Subject: Juniper Ridge Landfill Expansion Application, MEDEP #S-020700-WD-BI-N Follow-up to Department Staff's Responses to the March 4, 2016 Submittal on Staff's Review Comments as Presented in the Department's April 5, 2016 Letter

## EXHIBIT D

### **BGS AND NEWSME'S RESPONSE TO MEDEP'S APRIL 1, 2016 TECHNICAL MEMORANDA**

SKAPS, Industries  
Compression Creep Test Results via SIM  
Product Code: TN-330

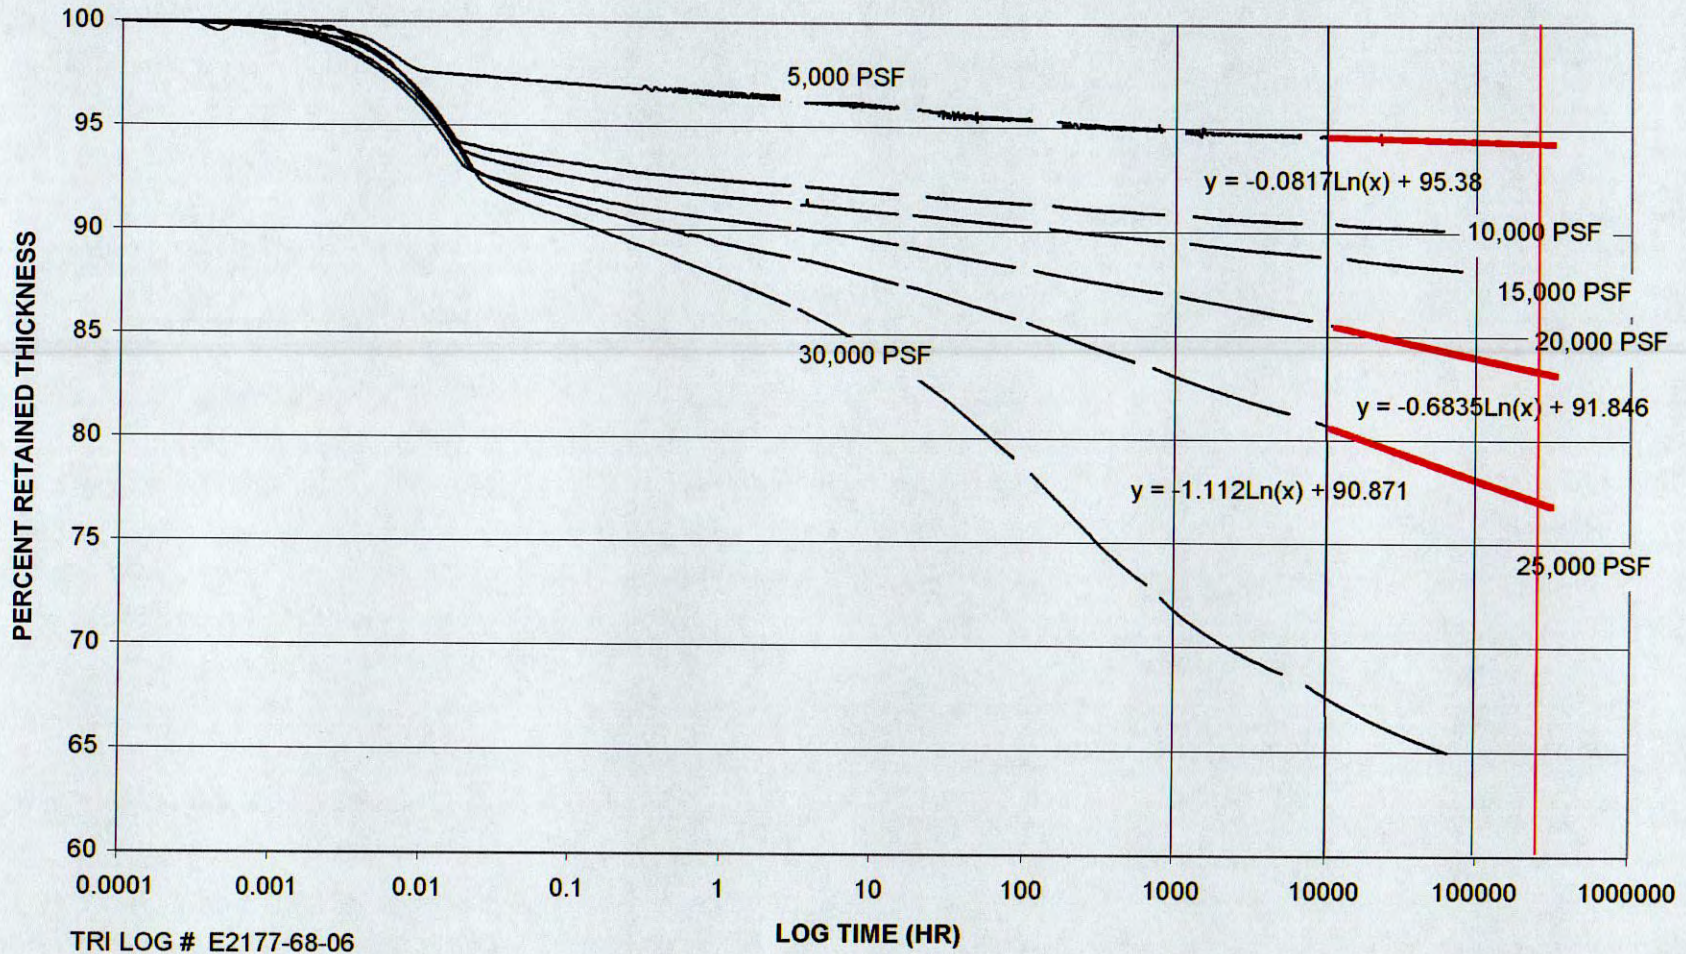
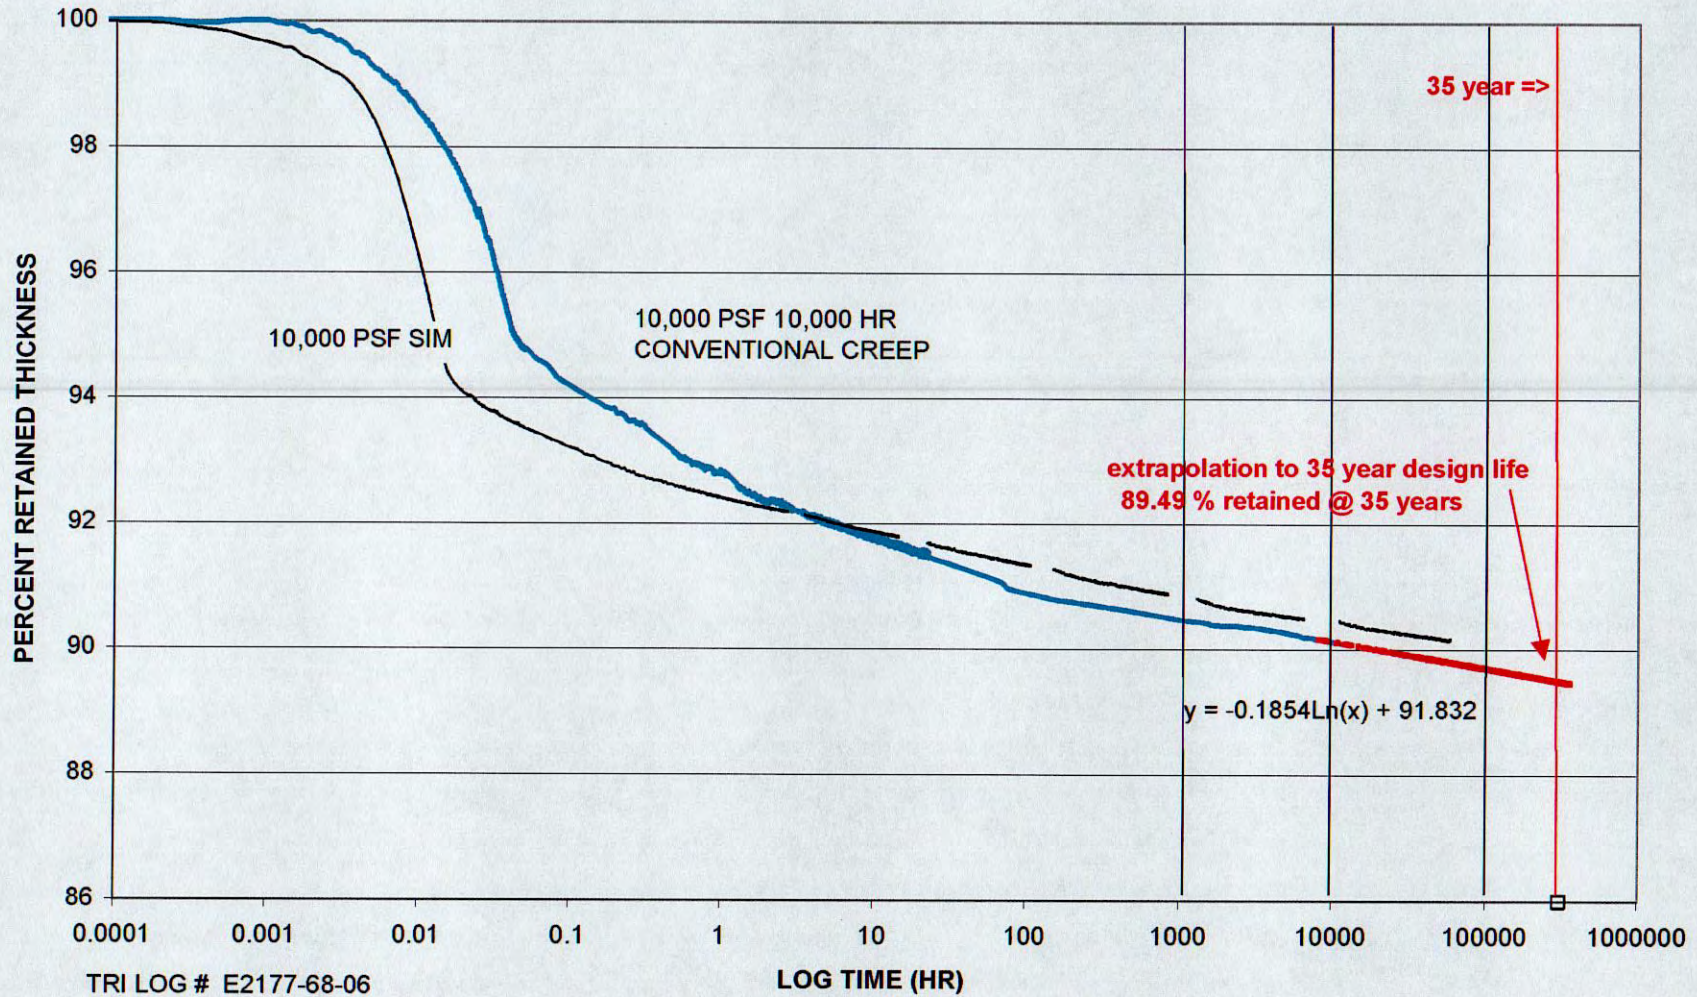
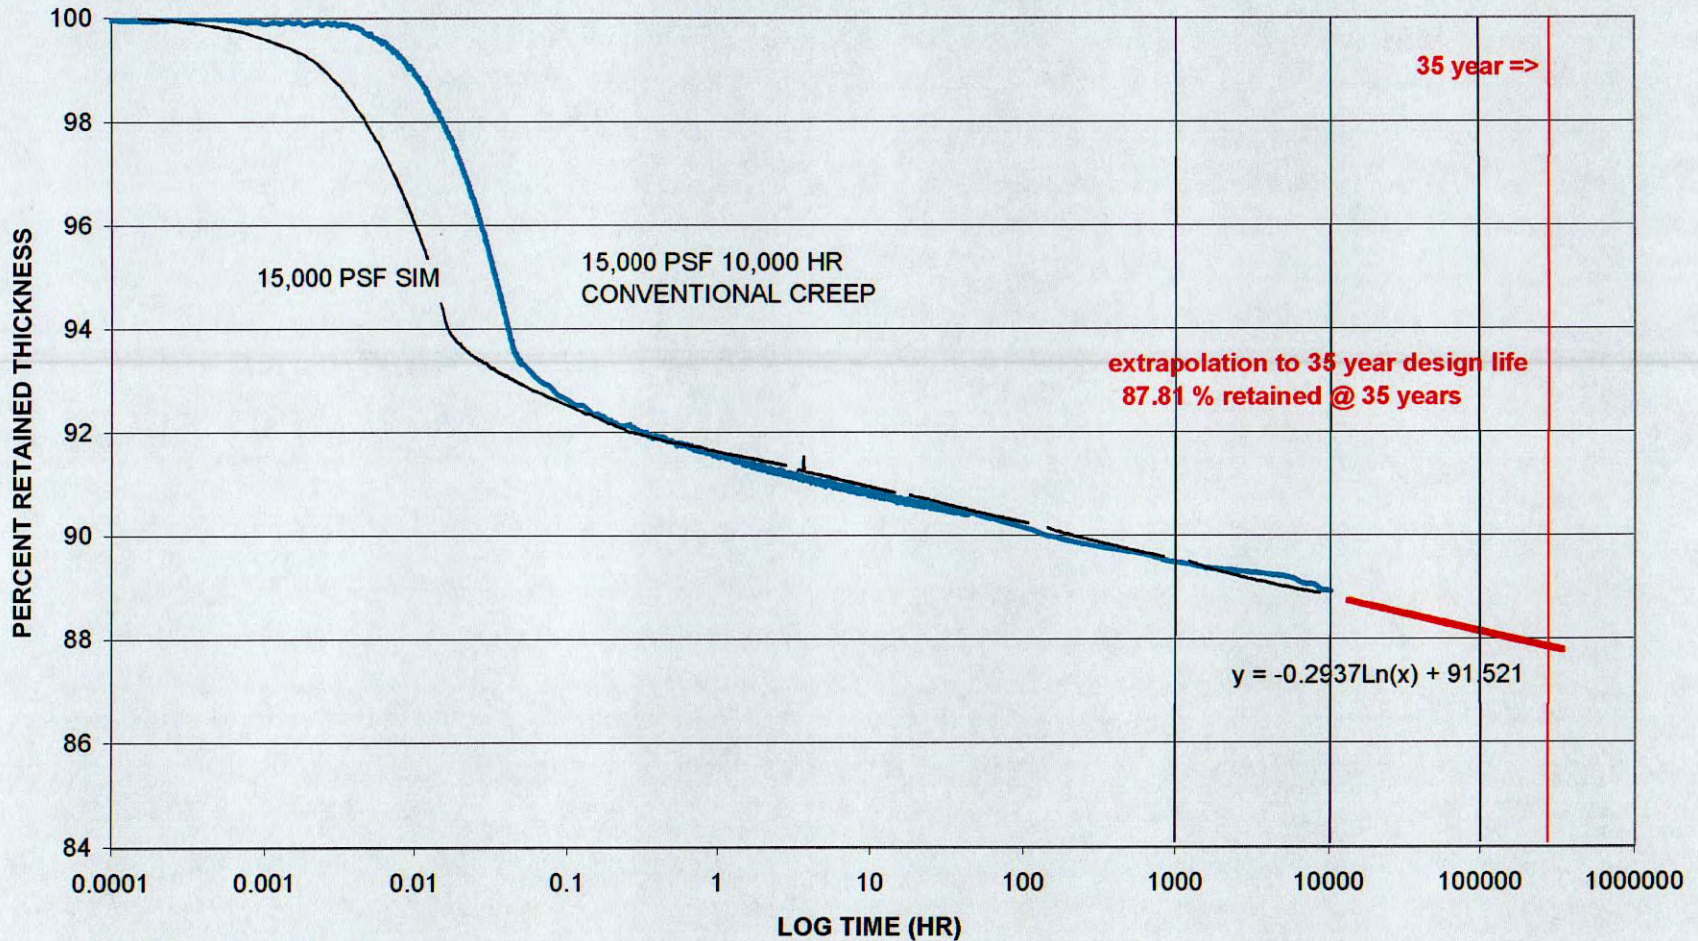
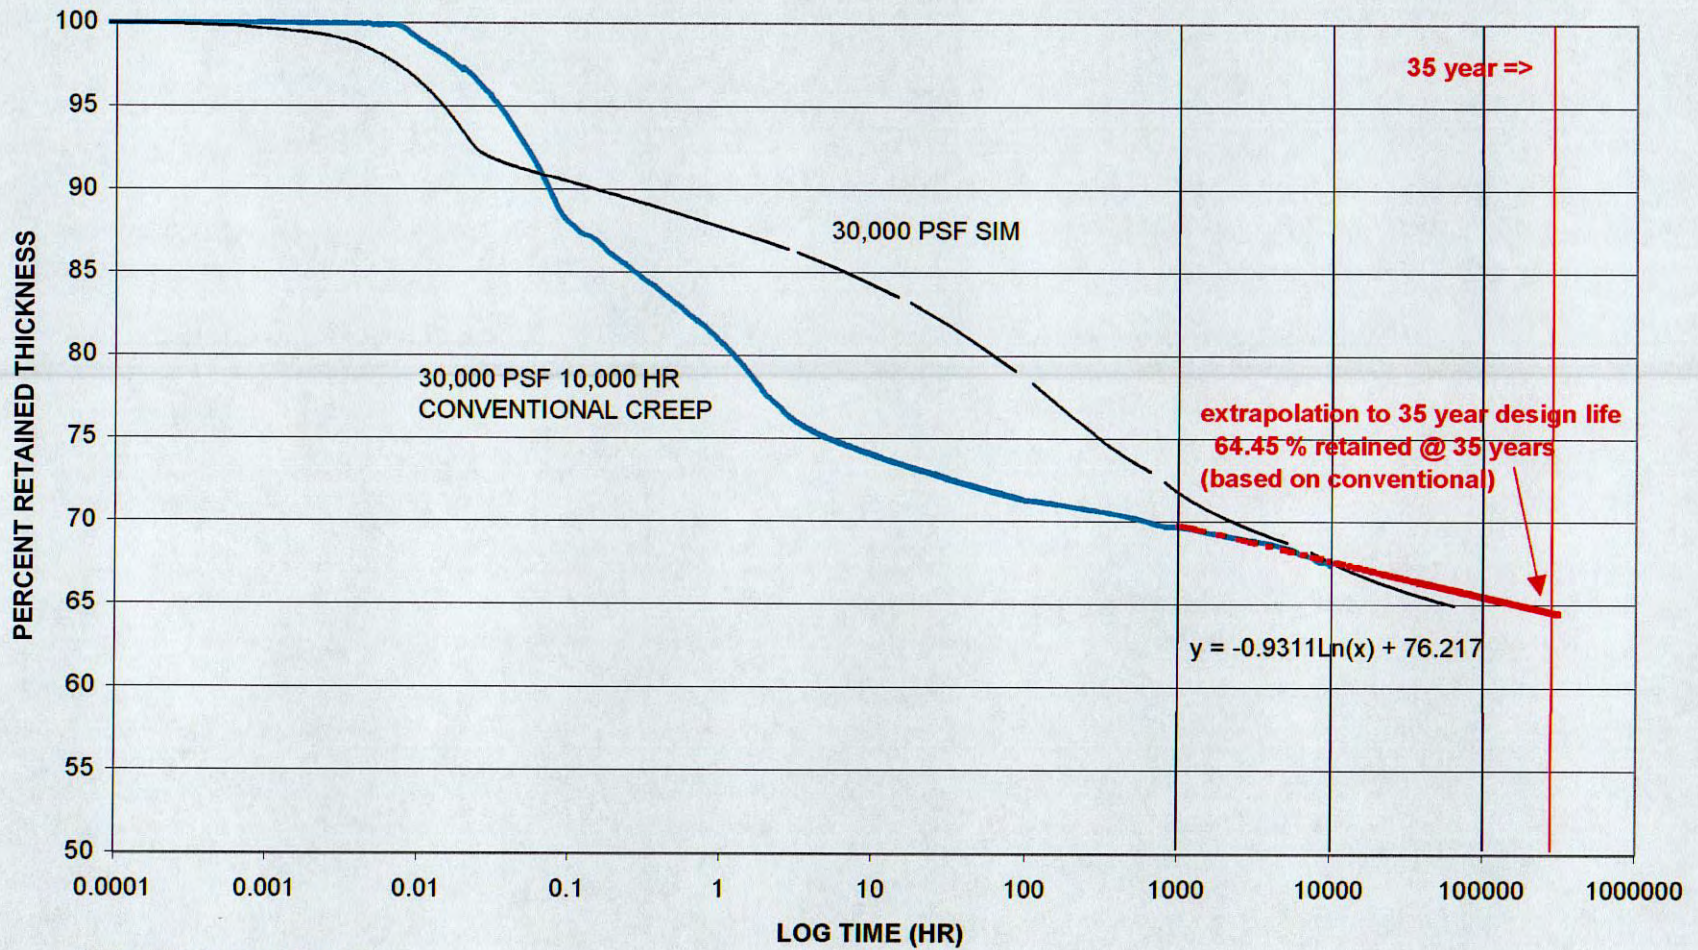
**MEDEP Follow-on comment II.L.1: Appropriate references justifying the reduction factors for chemical clogging, biological clogging, and intrusion have been provided. Reference is made to SIM testing completed by TRI that concluded that a reduction factor for creep as low as 1.1 is justified at normal loads of 15,000 psf. We request a summary of the referenced testing program.**

Applicants' Response: Included in Attachment SME-D8 is a summary of the reference testing program.

**OUTLET CONTROL STRUCTURE SCHEDULE**

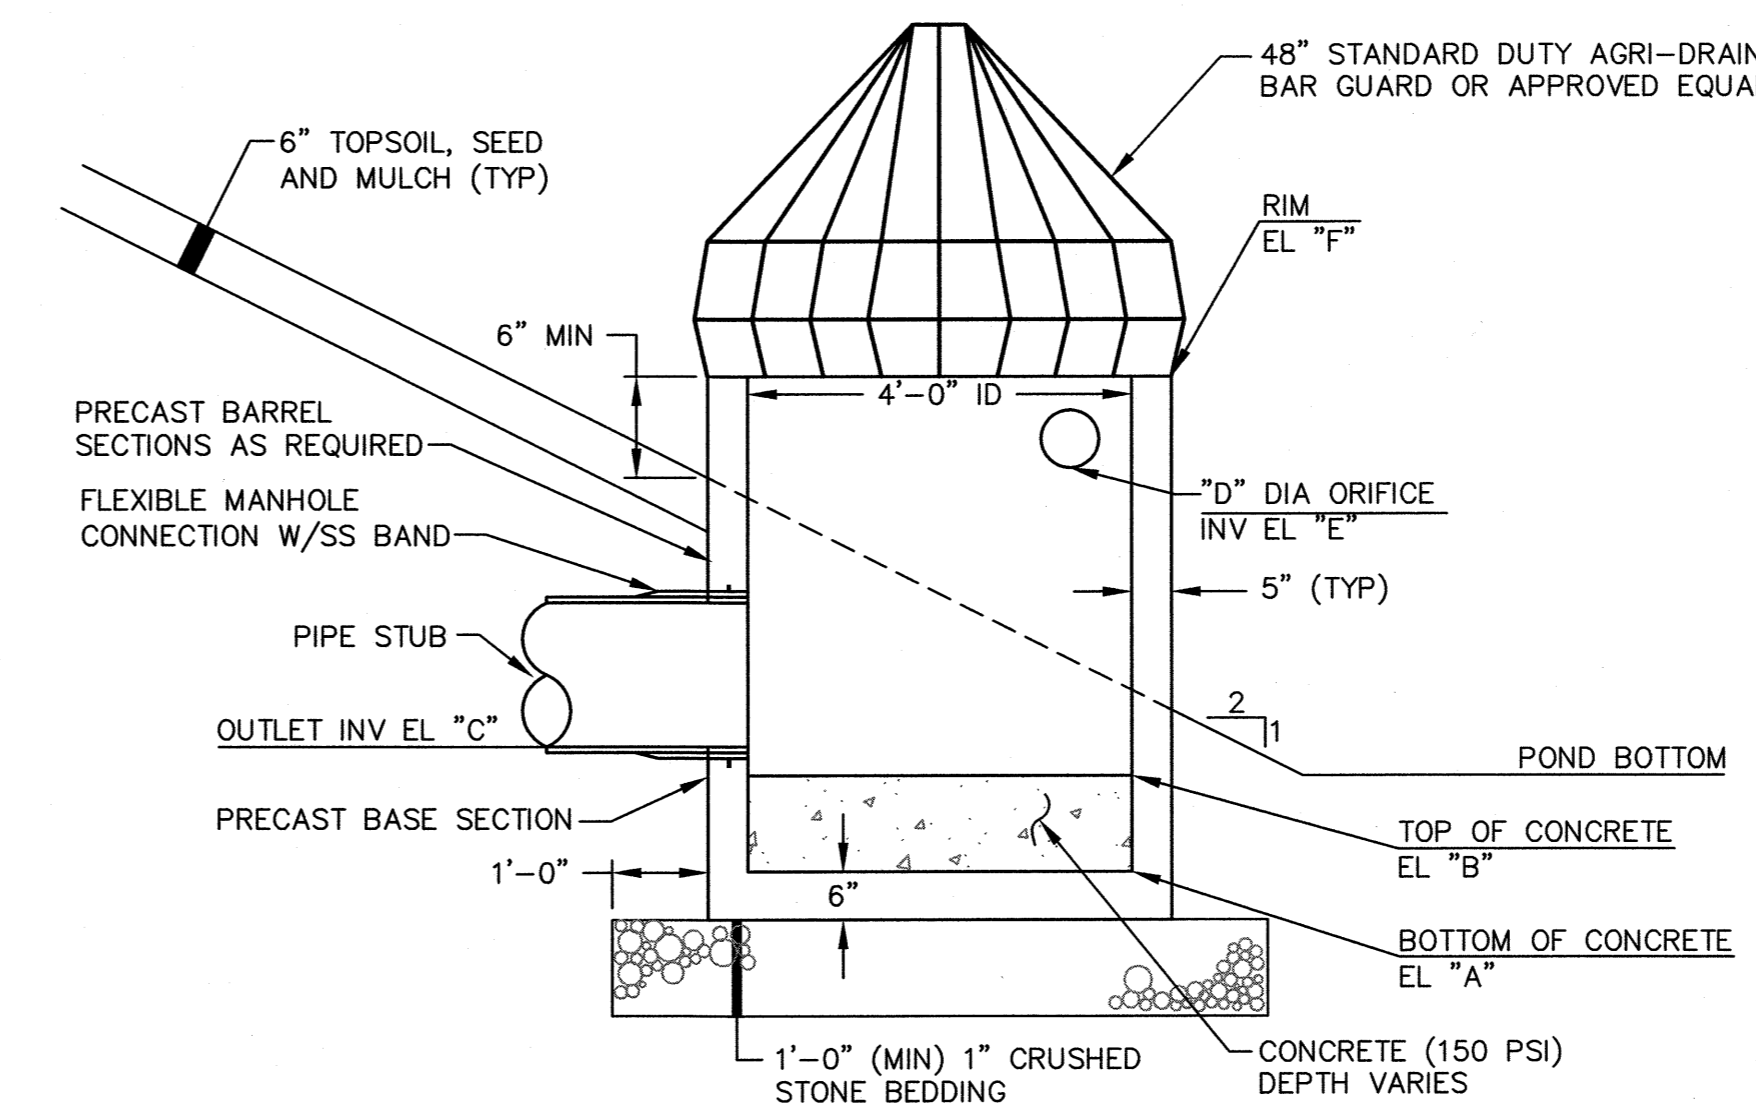
**MEDEP Follow-on comment II.N.10.a: The inlet invert elevation of Culvert C-2BA has been correctly revised. The slope has been revised to read 0.08% but should be 0.008% according to Table 7-1.**

Applicants' Response: Included in Attachment SME-D8 is a revised Drawing C-306 showing the corrected slope.
